Town of Gorham
Planning Board Meeting
July 10, 2023

ITEM 2 – Public Hearing – Site Plan – Patriot Holdings – Self Storage and Contractor Flex Space – a request for approval to construct eight 6,900 sq ft self-storage buildings, a 9,900 sq ft contractor flex building and associated infrastructure. Map 77, Lot 5. Zoned RC. The applicant is represented by Chris Taylor, P.E. at Sebago Technics.

Patriot Holdings – Self Storage and Contractor Flex Space
Site Plan Review
M77 L5 - Ossipee Trail Rd

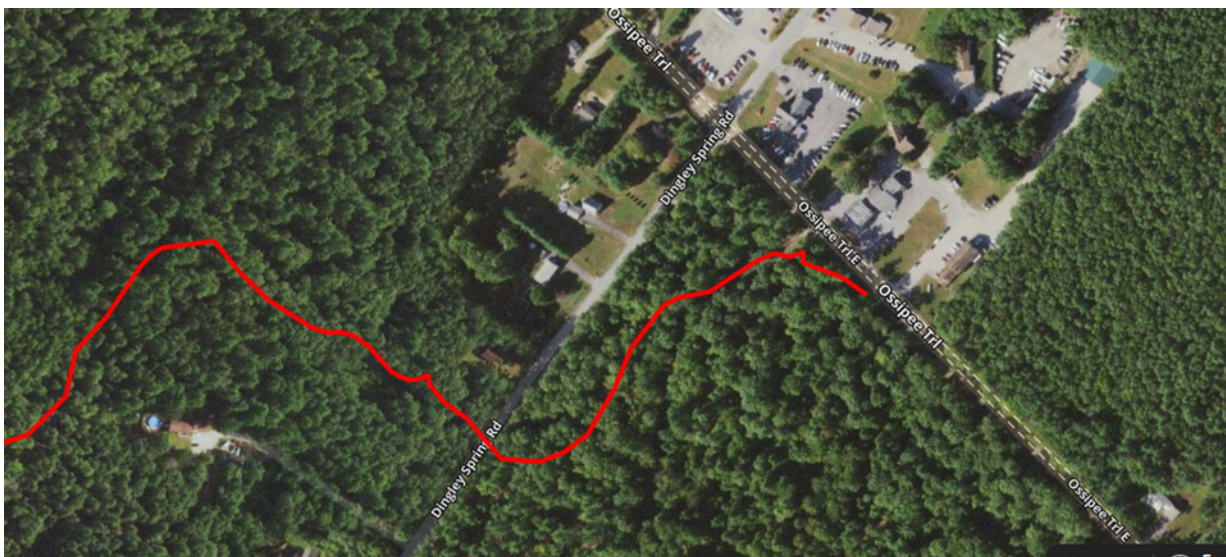
The lawyer for this company contacted me approximately 18 months ago in regards to the snowmobile trail that runs through the property. He asked for the landowner permission form and more information on the liability coverage through the State of Maine, both of which I provided to him.

For reference, the existing snowmobile trail crosses directly between Pit Stop Fuel and the Irving station and acts as a connector to the Standish trail system. We will be sure to GPS this shortly to ensure that we are all on the same page.
